**GENOA CHARTER TOWNSHIP  
ZONING BOARD OF APPEALS  
MAY 16, 2023  
6:30 P.M.  
AGENDA**

Case # 23-15

<b>Attention:</b>	Amy Ruthig, Planning Director
<b>Subject:</b>	E. Coon Lake Road – Dimensional Variance Review
<b>Location:</b>	E. Coon Lake Road – southeast side of E. Coon Lake Road, southwest of Chilson Road
<b>Zoning:</b>	CE Country Estate District

# SKETCH OF PARCEL ID #11-29-200-021

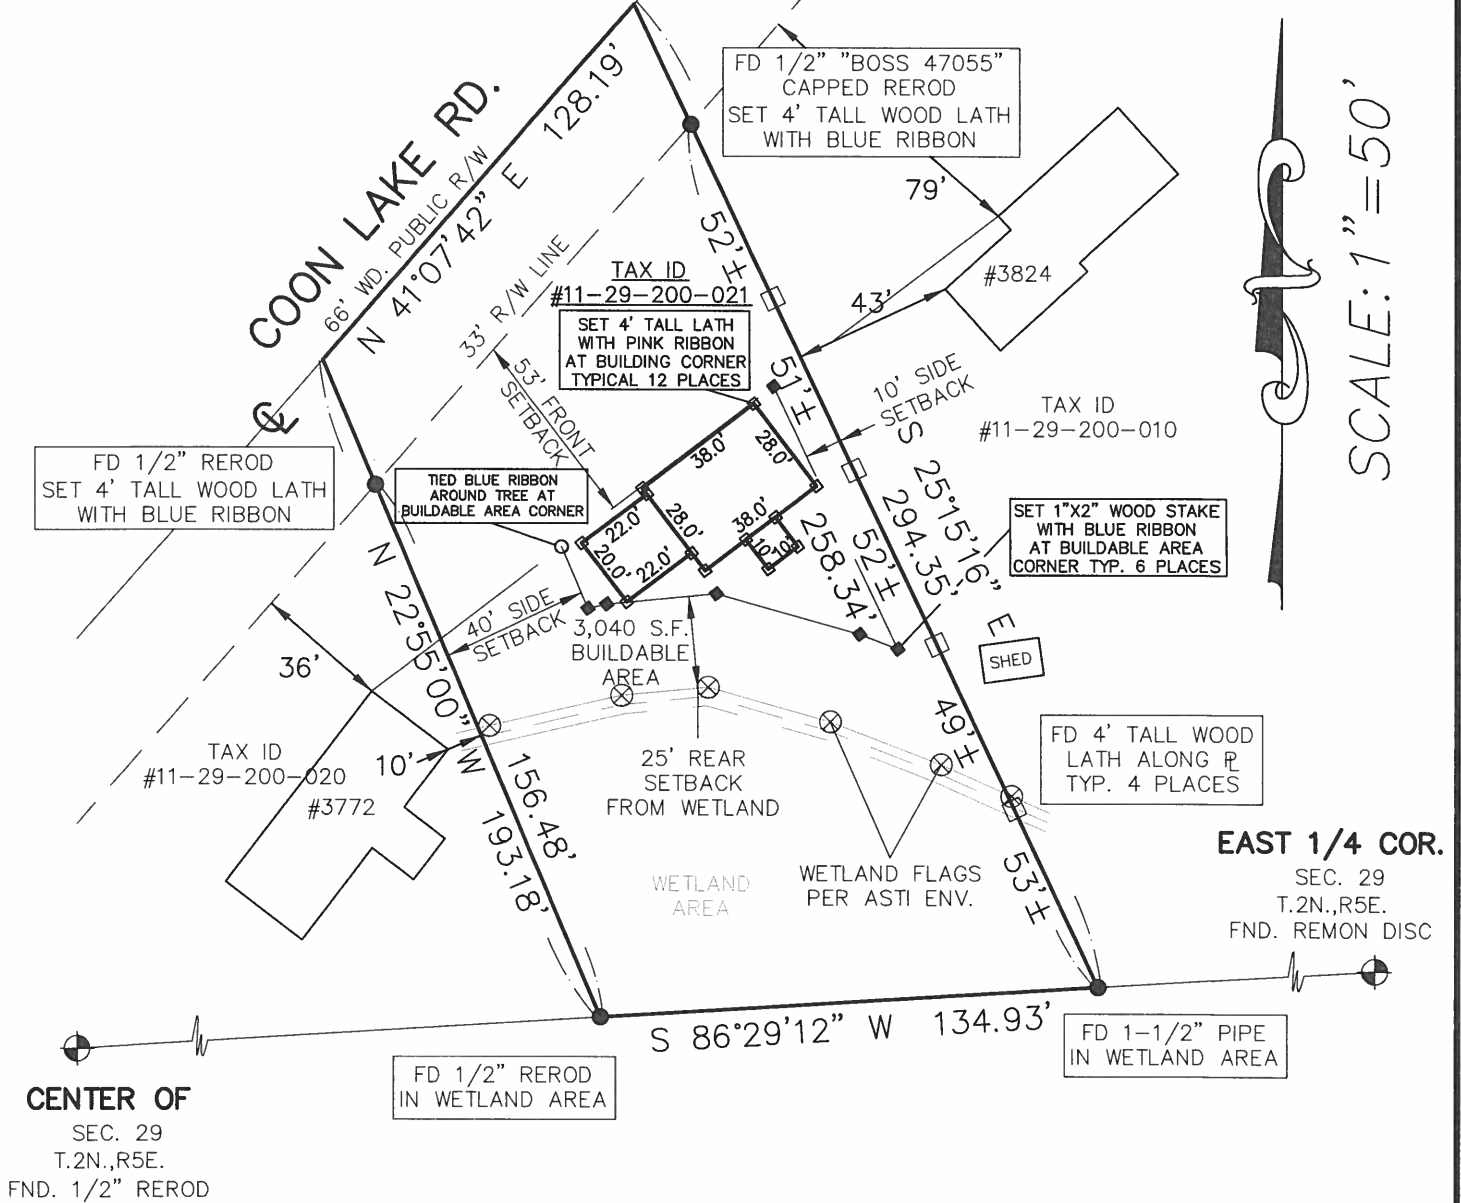
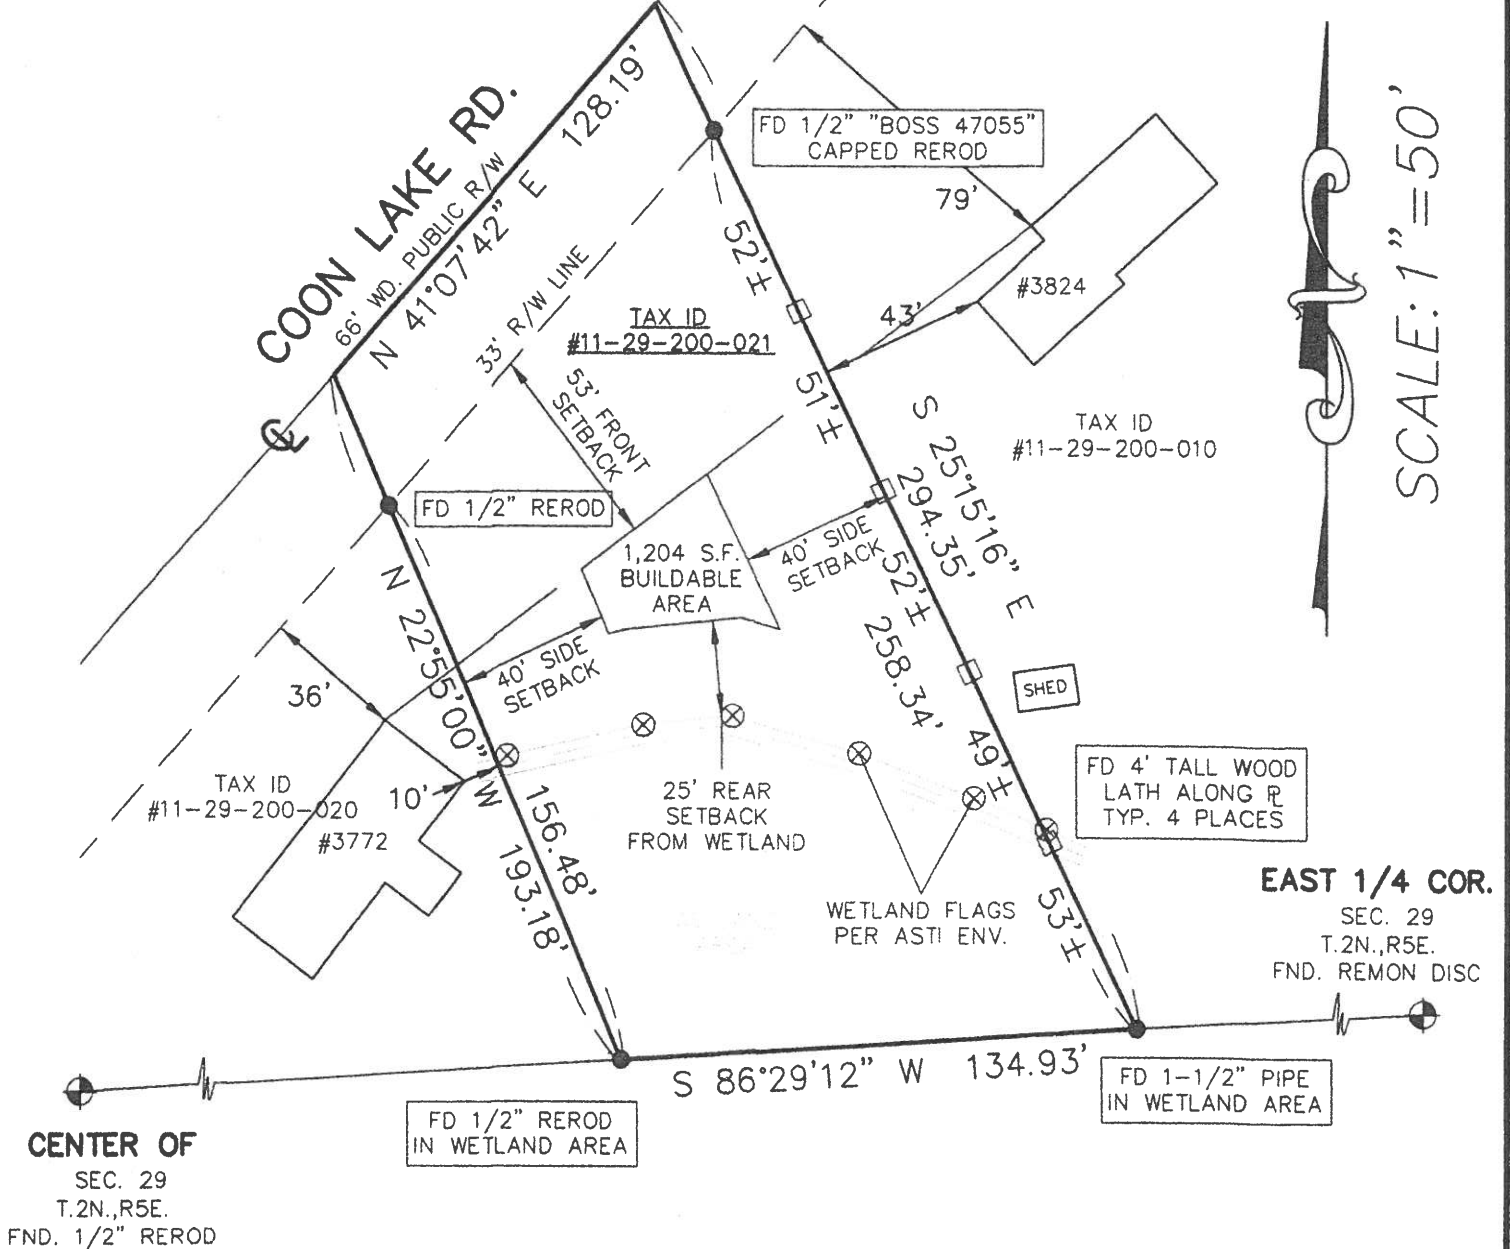
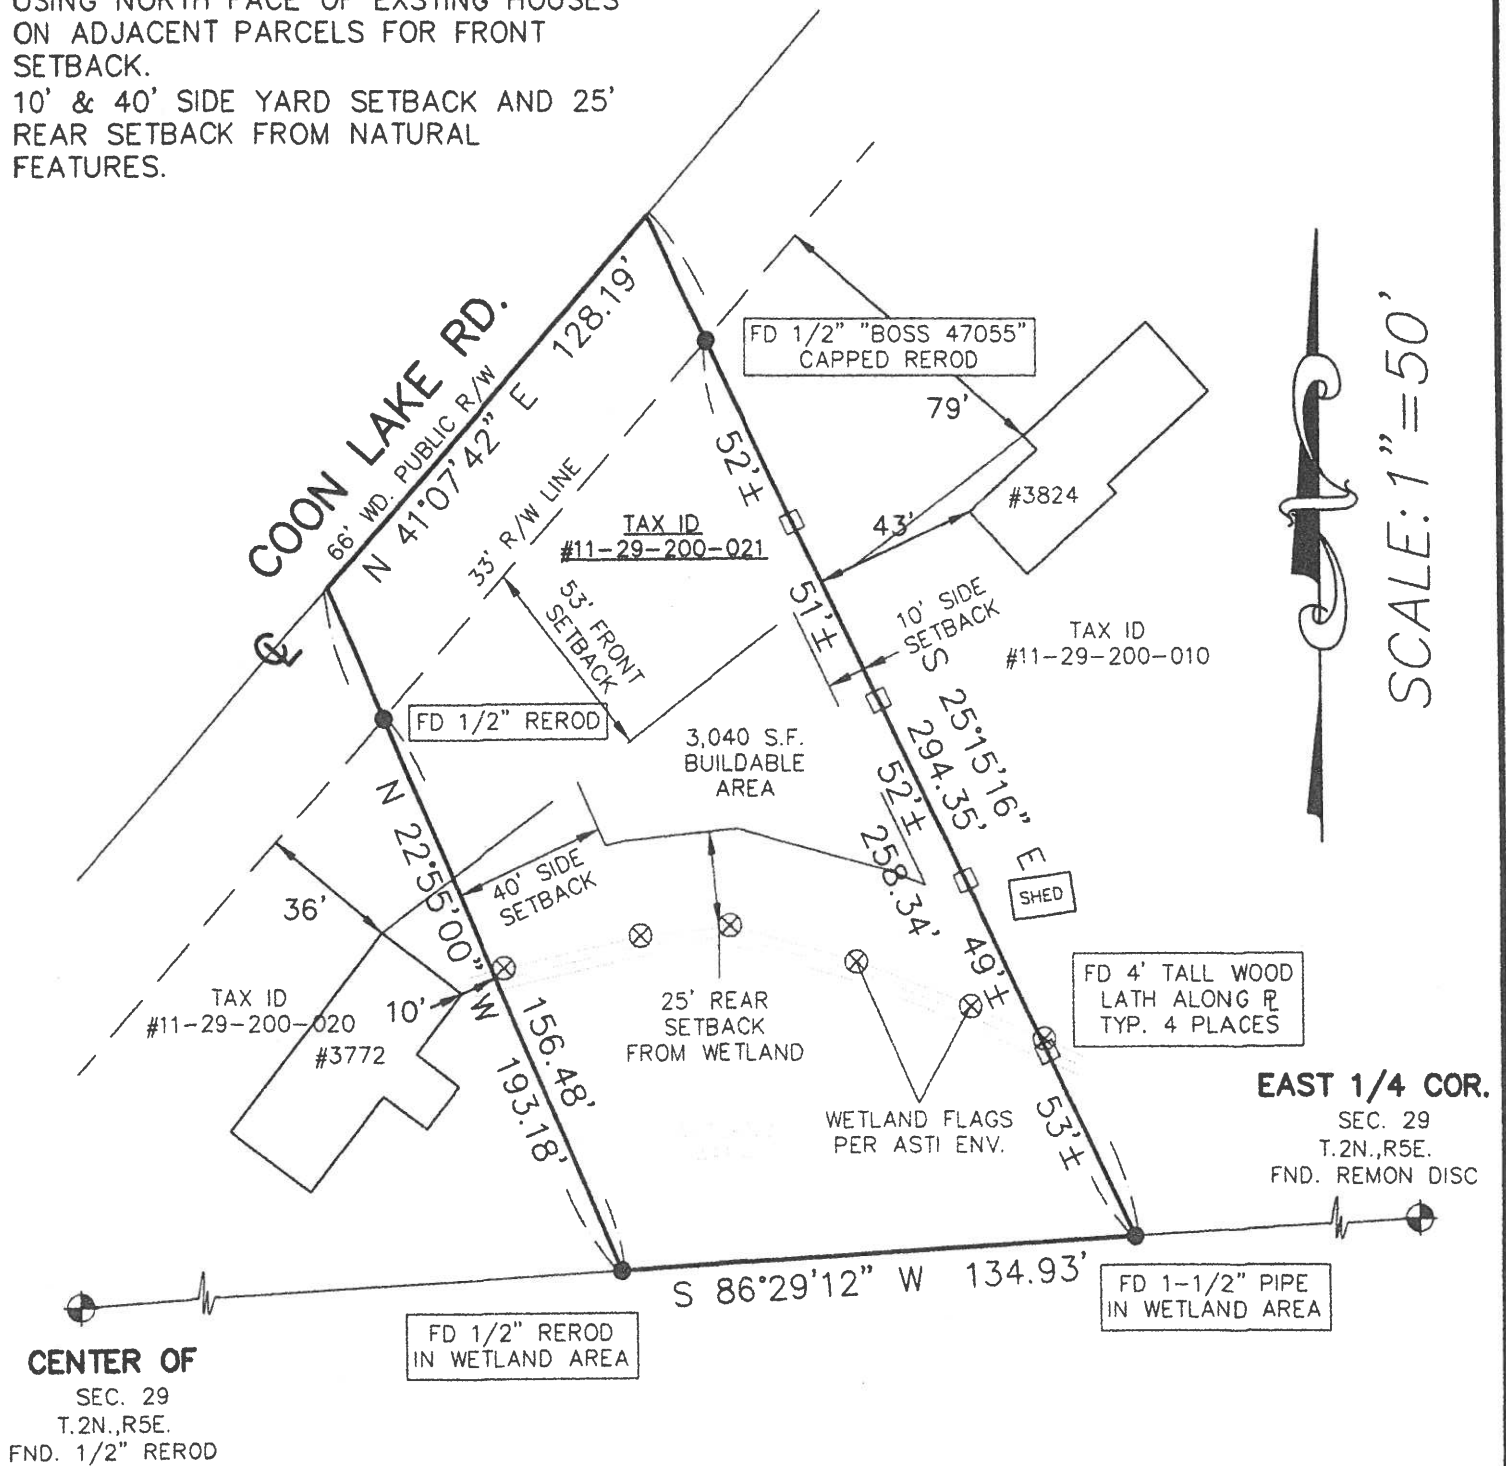
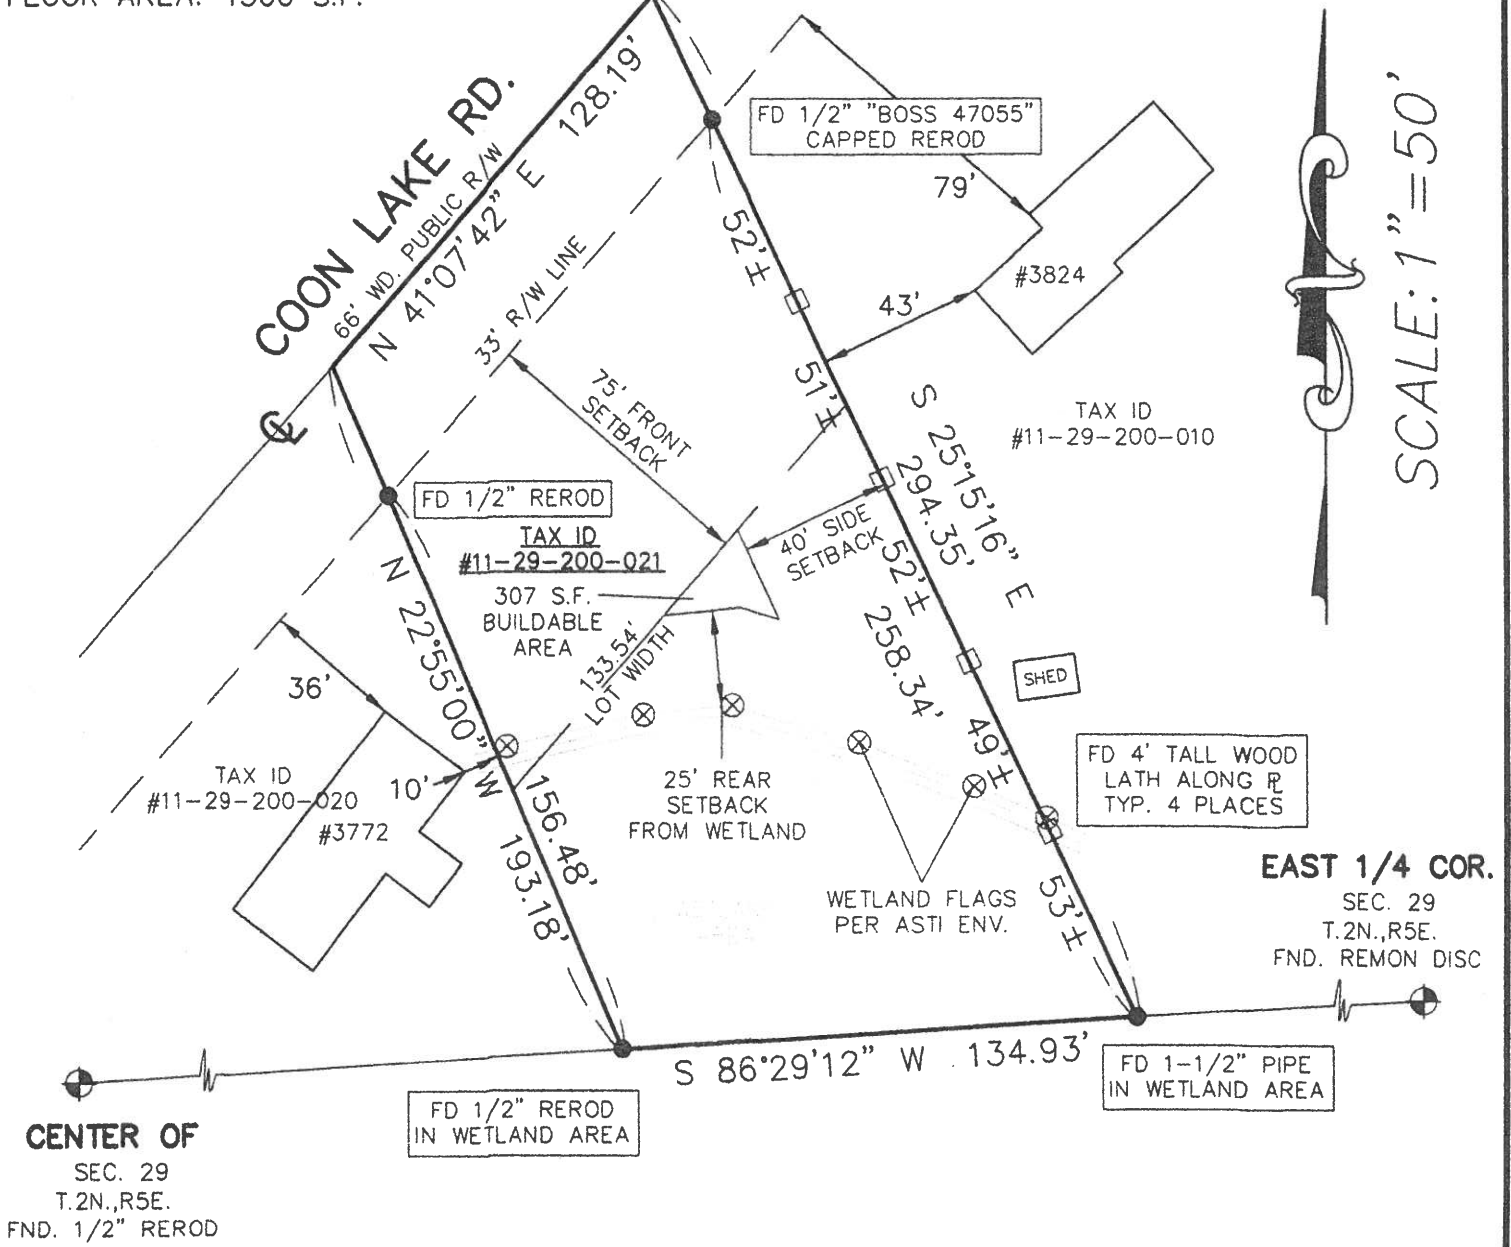
1. Variance requested/intended property modifications: Request is for a "Front Setback Variance" from 75' to 53'+/- Variable Depth, measured from RLW to a line between the front faces of the two adjacent houses. Request is for a 30' variance in East "Side Yard Setback" to allow for construction of a house similar in size to adjacent houses. The "Rear Yard Setback" is based upon the 25' "wetland setback." Due to a large area of wetland in the rear yard that poses an additional hardship for the parcel.

- A front yard setback of 53’ (where a minimum of 75’ is required);
- A side yard setback of 10’ (where a minimum of 40’ is required); and
- A floor area of 1,064 square feet (where a minimum of 1,500 square feet is required).

PROJECT		4437 FILBERT	
PREPARED FOR		CHEUNARD CUSTOM HOMES	
TITLE		BOUNDARY/TOPOGRAPHICAL SURVEY	
NO. BY	REVISION PER	DATE	
DESIGNED BY:	DRAWN BY: AEB		
CHECKED BY:	SCALE: 1" = 20'		
JOB NO.	16-051		
DATE	3-3-16		
SHEET NO.	1 OF 1

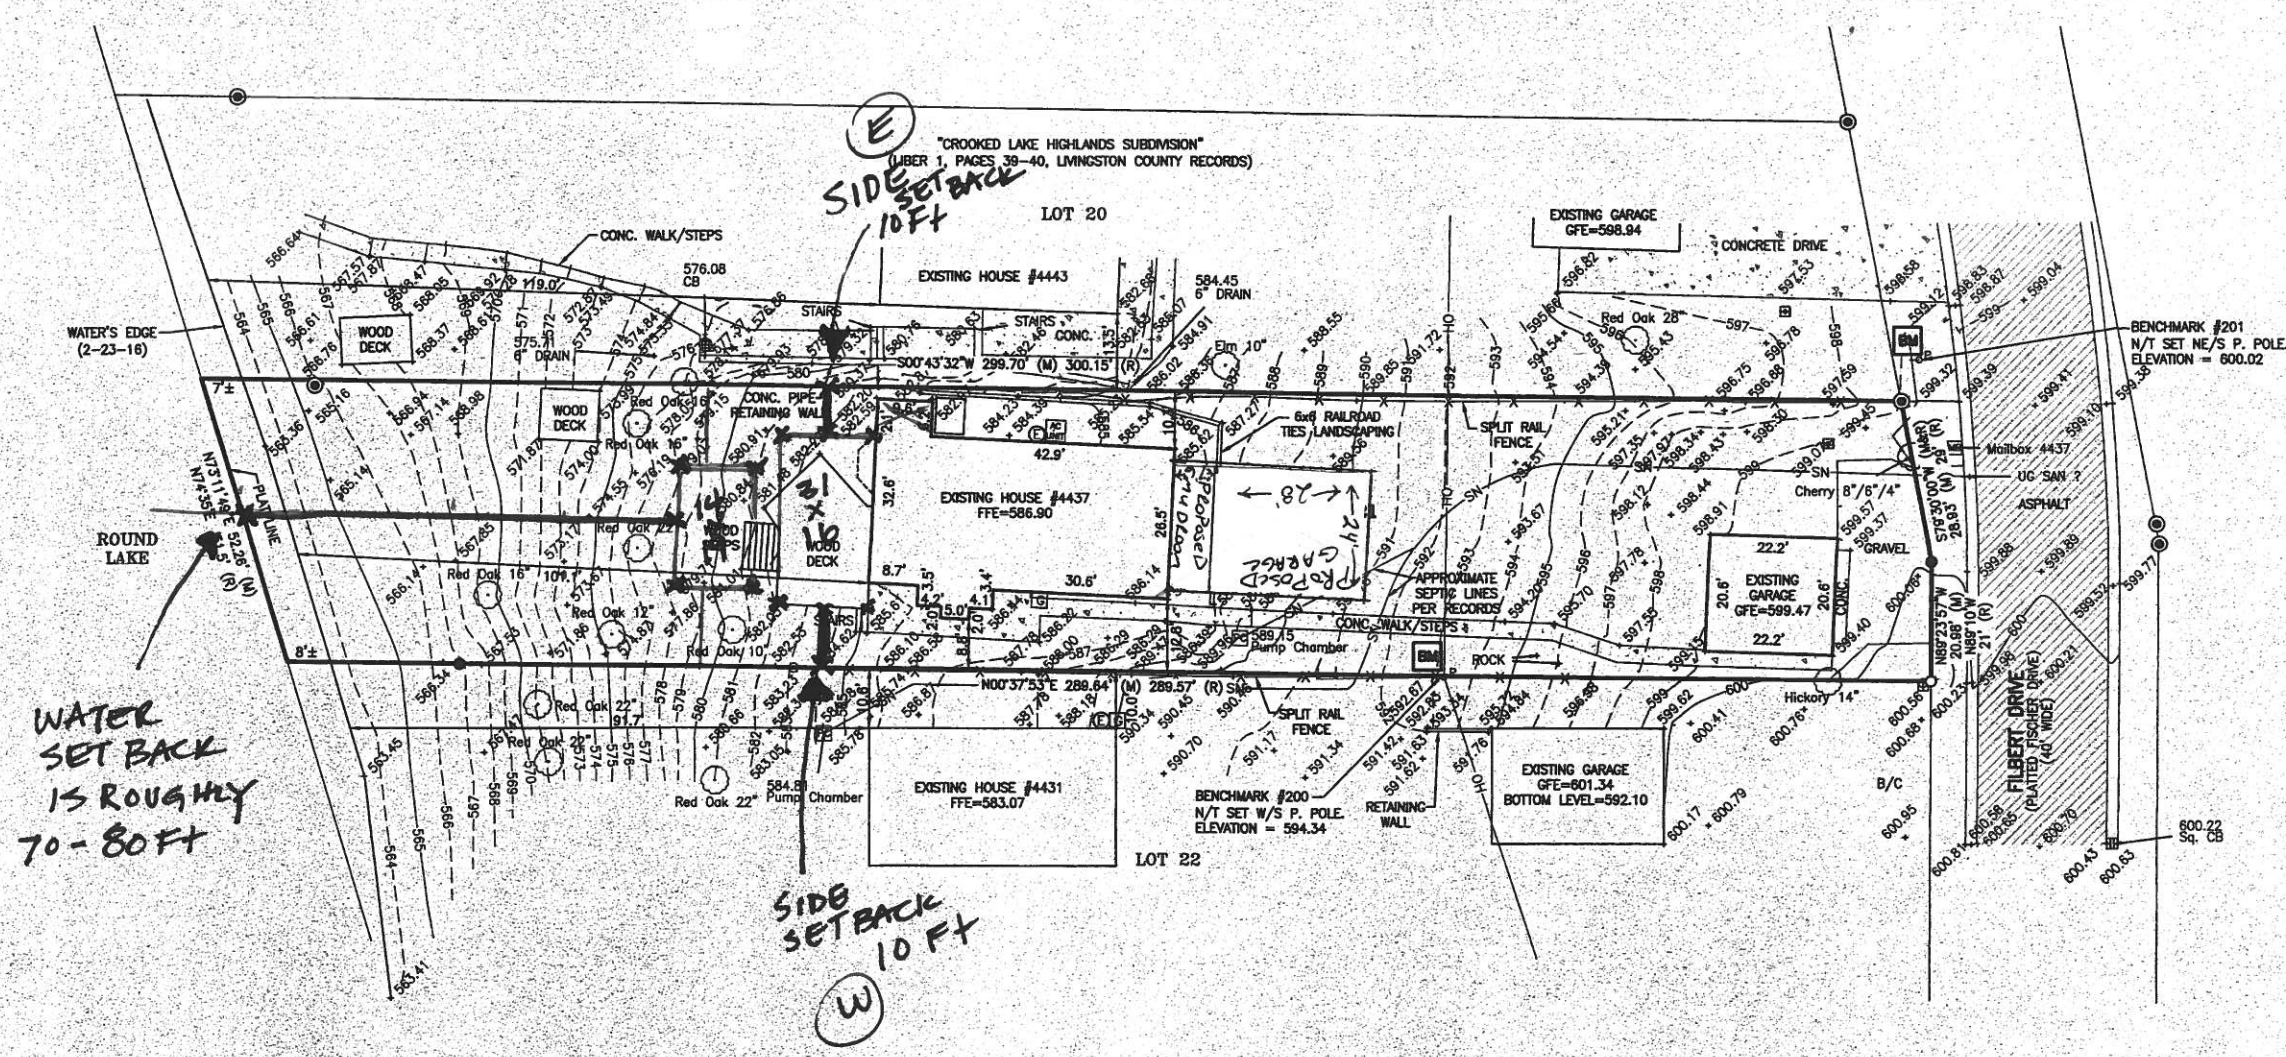
The drawings provided do not confirm that this is the case, nor are we able to verify via aerial photos.

In order to demonstrate compliance with this standard, the applicant must provide supporting evidence to the Board's satisfaction.
